Subject: Submission - Modification Application No. Mod2021/1009 [MCR-W.FID4054884]

Re: 82-84 Bower Street, Manly | Modification Application No. Mod2021/1009

Re: 82-84 Bower Street, Manly | Modification Application No. Mod2021/0317

Photograph 1: Depicting view and potential for direct overlooking into the private open space (pool area) at 86 Bower Street, taken looking west from the balcony at 84 Bower Street, Manly.

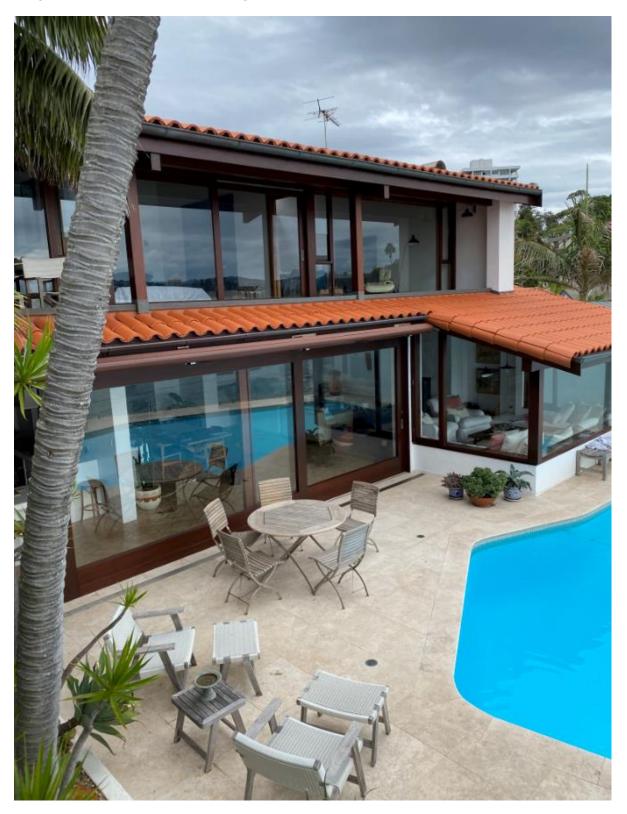
- 17 If the Modification was approved, overlooking into our client's property will be readily achievable. Future occupants of the Property will be able to view all the primary living areas of our client's home, including the ensuite bathroom, lounge room and main bedroom (on the second storey), in addition to the kitchen, dining room, private open space (including the pool deck), main living and dining room (on the first storey). These rooms could be observed not only from the Property's balcony, but also from their kitchen and living areas. The photographs behind **Annexure G** provide an indication of the direct views into our client's kitchen and living room areas that could be observed if the Conditions were not imposed.

Photo 1 (showing views from internal areas and balcony into kitchen, dining, main lounge, upstairs lounge, bedroom and bathroom)

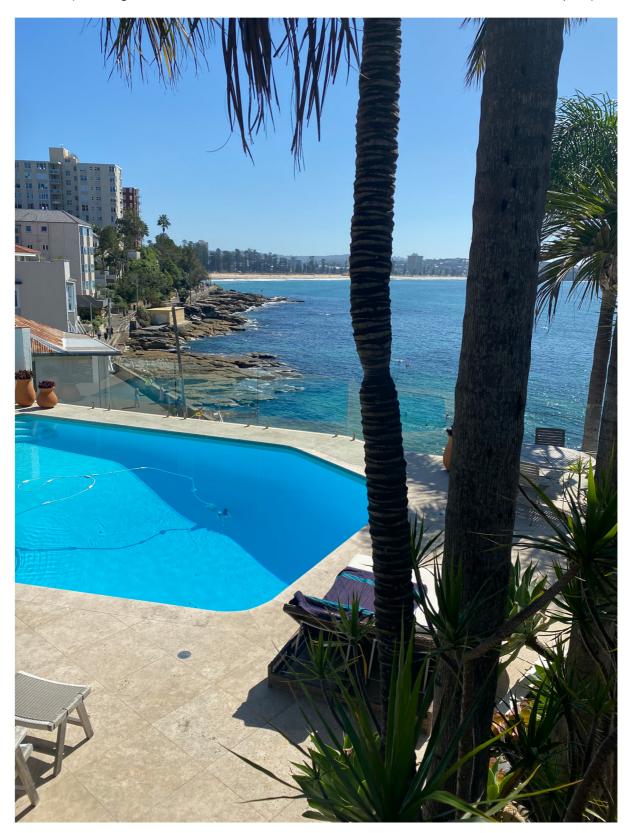
This is a matter of planning principle and the right of one neighbour to have privacy over the desire of another neighbour to have excessive views despite the loss of privacy and amenity this would result in for the other. The Applicant enjoys beautiful views, as do all the homes along this stretch of Bower Street. The proposed screening as required by Conditions 7 and 8 does not negate these views. See Photo 5.
